RE: Chemtrade Performance Chemicals: Rule Exemption Request, Chapter WAC 480-60

This request relates to an existing Chemtrade tank car unloading station on the Kalama site premises. The unload facility consists of a single load/unload station on a single dead end spur on the Kalama site. The existing unloading station gangway is being upgraded to a new retractable gangway with a safety cage to comply with OSHA fall control requirements.

ACCESS WALKWAY/GANGWAY GENERAL ARRANGEMENT

DWG-S1

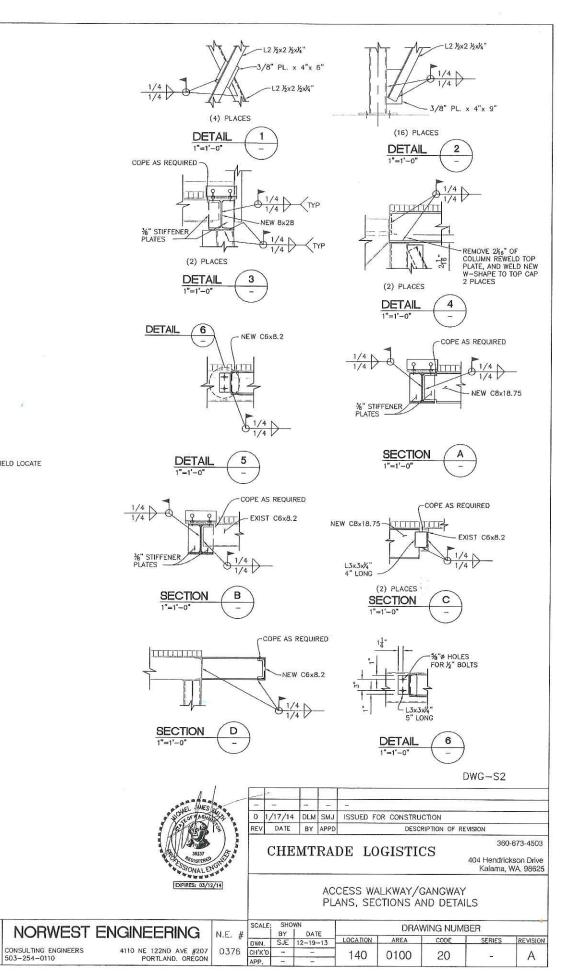
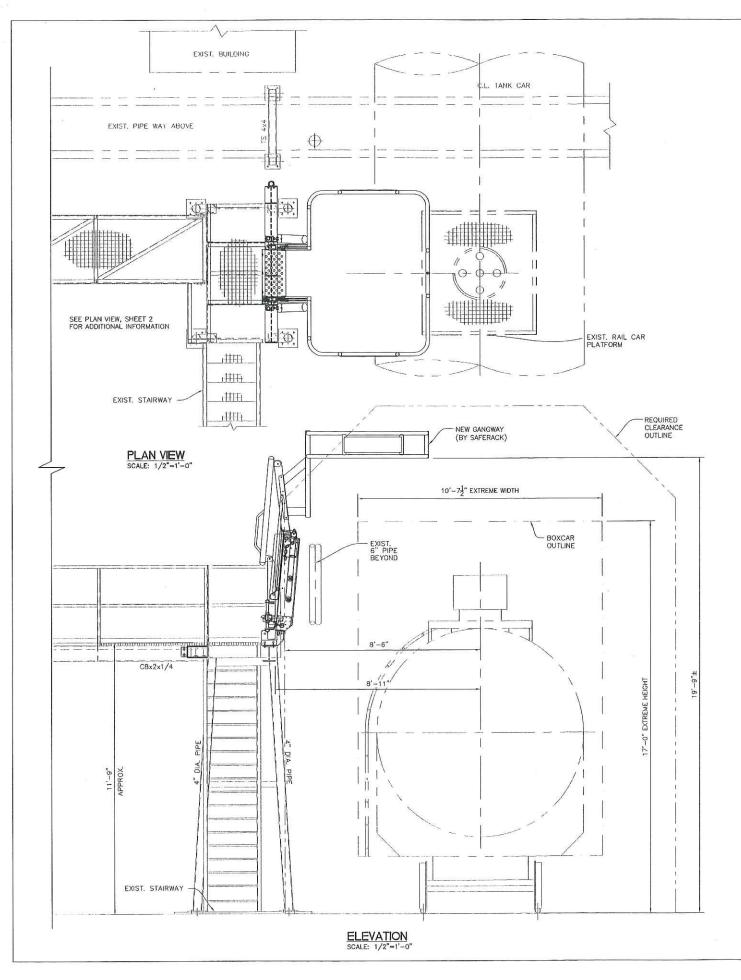
• The minimum overhead clearance attained by the Chemtrade proposed design is less than that required by WAC 480-60-040 with the bottom of the safety cage being at 19'-9" above the top of the rail in the stowed position. See attached drawing S1.

• The minimum side clearance attained by the Chemtrade proposed design meets the criteria required by WAC 480-60-050 for icing platforms. The safety cage in the stowed position has approximately 8'-0" clearance from the track centerline. See attached drawing S1.

- 3) Although the proposed retractable platforms infringe on the overhead prescribed by WAC 480-60, the attached exhibit demonstrates that the fully stowed retractable platform allow, for ample clearance of a tank car and locomotive.

- 1) The retractable platforms are to be extended to tank cars and operated by Chemtrade employees after delivery of cars by Burlington Northern Rail. The platforms will then be returned to the fully stowed position prior to removal of cars by Burlington Northern. Therefore the lower vertical clearance of the safety cage in the upright position does not negatively affect Burlington Northern operations. Burlington Northern will not service the unloading facility area unless the retractable platforms have been returned to the stowed position. Burlington Northern Rail will issue instructions to train crews advising of the maximum height of rail cars allowable to this spur.

- 2) The loading structures are to be located inside the fenced area at Chemtrade. With the proposed clearances and fully stowed retractable platforms, Burlington Northern trains will be able to clear the structures; however the close clearance would present a risk to individuals riding on the top of the railcar within the fenced area. Although train crewmembers have no reason to ride on the top of a railcar, all parties agree that any clearance exemption should be conditional upon a prohibition against riding on the top of a railcar approaching or underneath the loading structures; and clearly making and signing the proposed rail yard facility as having lower vertical clearances.
